PARTS & SERVICE NEWS

REF NO.	AA98162
DATE	Aug. 18, 1998
(C)	Page 1 of 4

SUBJECT: CHANGE OF TRANSMISSION ON WA900-1

PURPOSE: To introduce the procedures to modify the transmission on WA900-1 wheel loaders to the WA900-3 type transmission.

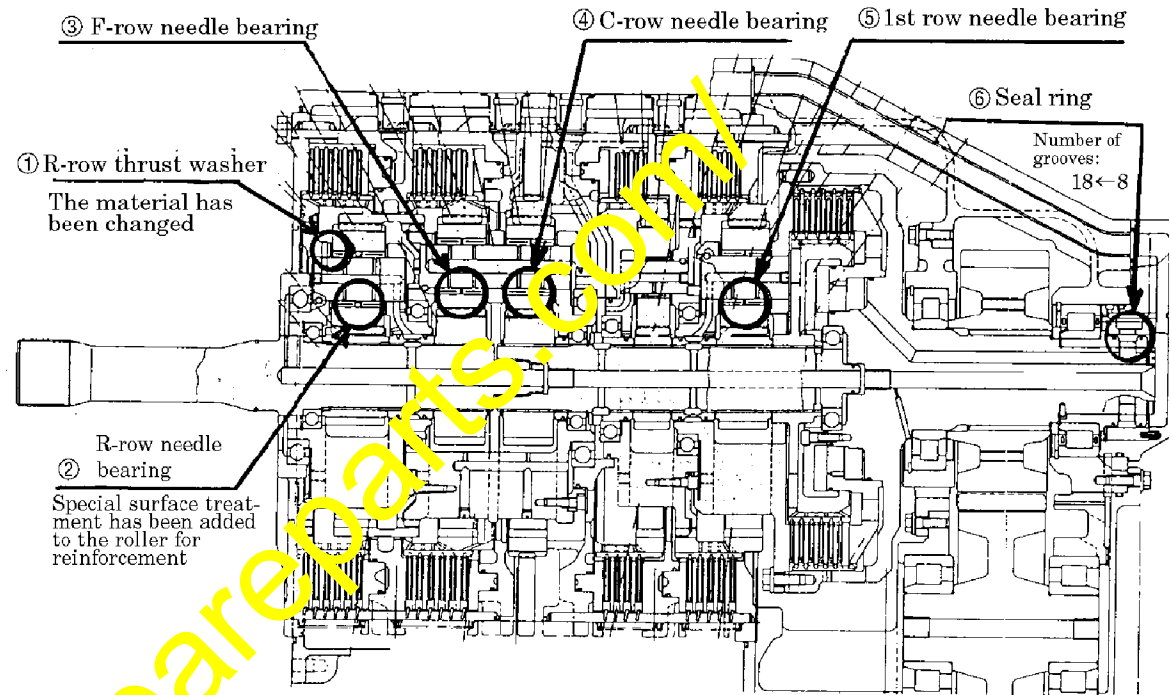
Transmission

No.	Part names	"3" type transmission ← "1" type transmission		Remarks		
		Part No.	Q'ty		Part No.	Q'ty
①	Thrust washer	198-15-22571	8	427-15-12560	8	The material has been changed. Black synthetic resin ← Copper alloy
② ⑤	Bearing	427-15-19320	32	582-15-19720	32	Special surface treatment has been added to the roller. Distinguishable by cage color: Black ← Neutral (Metallic color)
⑥	Seal ring	427-15-19220	2	07018-21104	2	Number of grooves: 18 grooves on both surfaces ← 8 grooves

Control valve

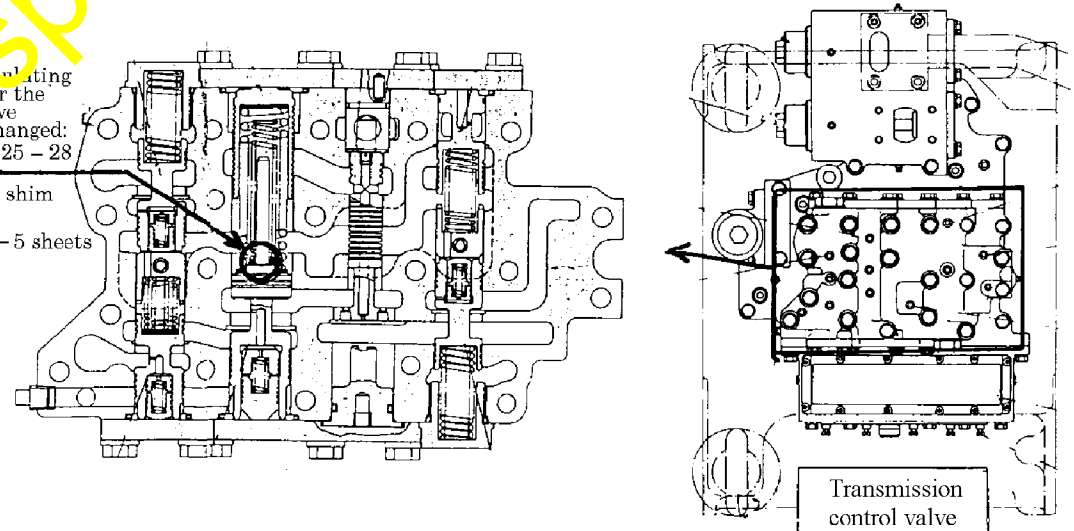
No.		"3" type transmission ← "1" type transmission	Hydraulic pressure measuring conditions
	Modulating pressure	27 - 30 kg/cm ²	25 - 28 kg/cm ²
	Part number of the shims	560-43-14330	560-43-14330
⑦	Shim thickness per unit	0.5 mm	0.5 mm
	Standard shim quantity	10 sheets	5 sheets
			Engine at Idle-Idling revolution Speed shift stage: Neutral Oil temperature: 60 - 80 °C Hydraulic pressure adjusting range per a shim: 0.42 kg/cm ² .

⑦ The modulating pressure for the control valve has been changed:
27 - 30 ← 25 - 28

Standard shim quantity:
10 sheets ← 5 sheets

4. Modification procedures for reinforcement: ① – ⑥

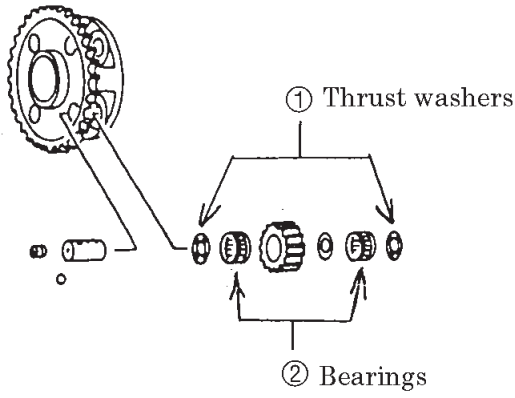
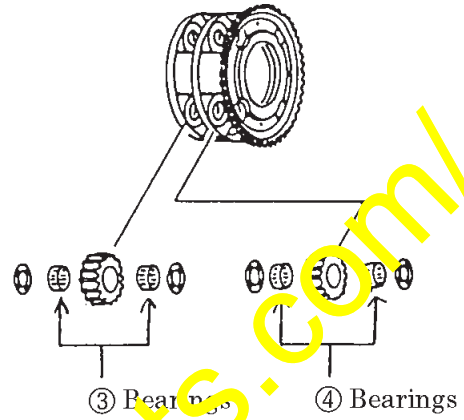
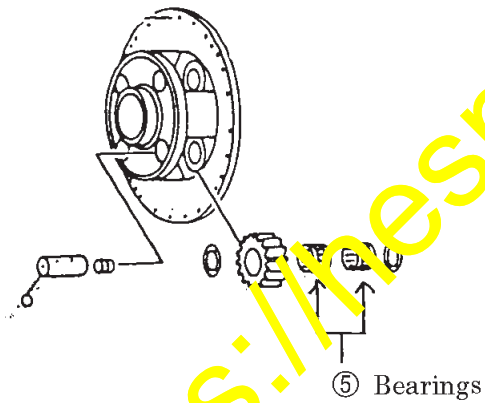
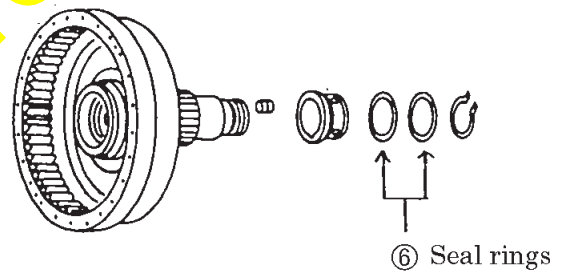
Replace the parts ① – ⑥ with the improved parts referring to the Section "Disassembly and assembly" in the Shop Manual.

4. Modification procedures for reinforcement: ⑦

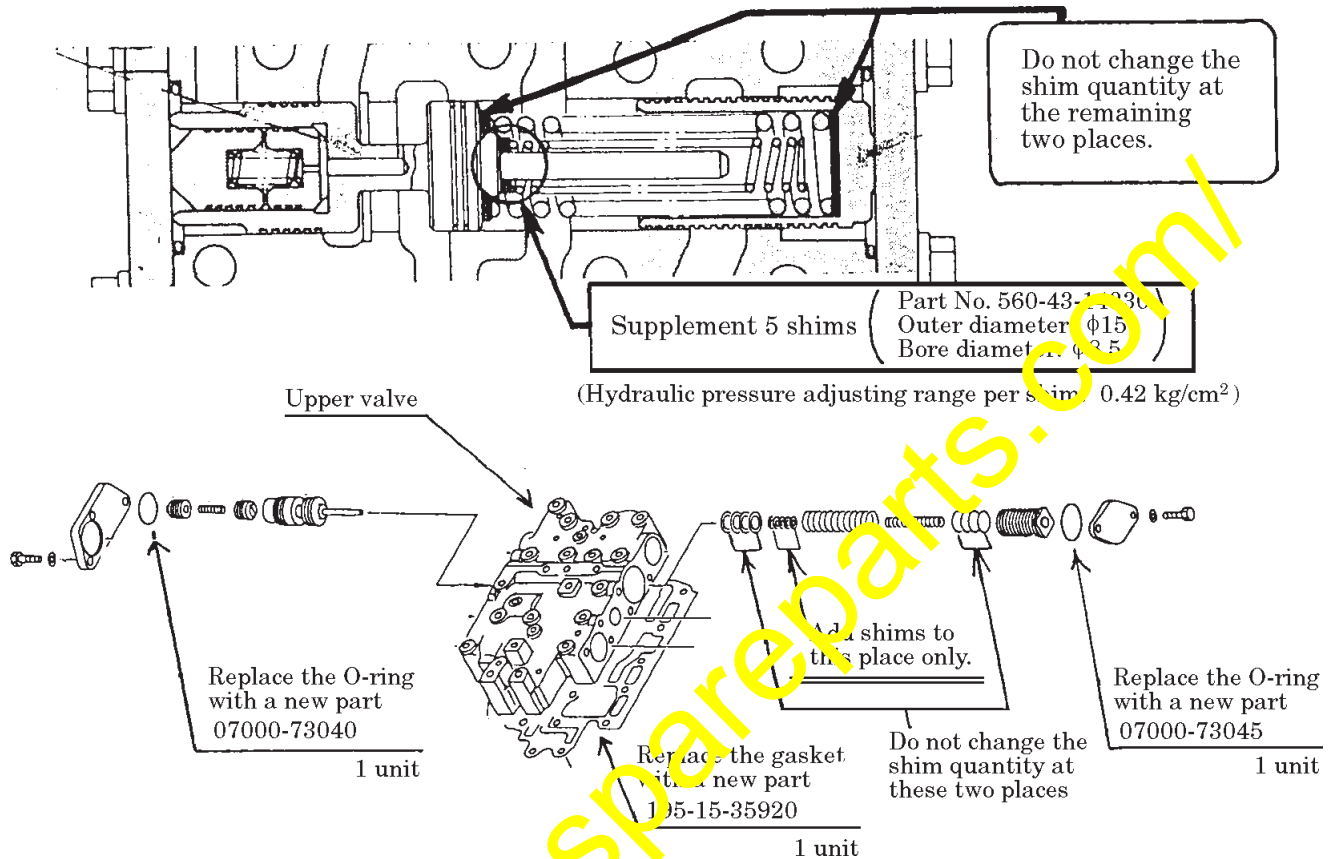
- (a) Remove the upper valve from the transmission and supplement shims to the modulation valve referring to the Section "Disassembly and assembly" in the Shop Manual.

(Note 1) Before starting disassembly, wash the area around the valve and, when removing the upper valve, pay great attention not to allow entry of dust or other foreign substances into inside the valve.

(Note 2) Replace the consumable parts such as the gasket and O-rings as are indicated above with new parts.

- (b) Check and confirm that the modulating pressure is within the hydraulic pressure range after the modification (27 – 30kg/cm²).

When the modulating pressure is found to be out of this range, re-adjust the shim quantity in the same manner as outlined above to bring the modulating pressure within the specification.
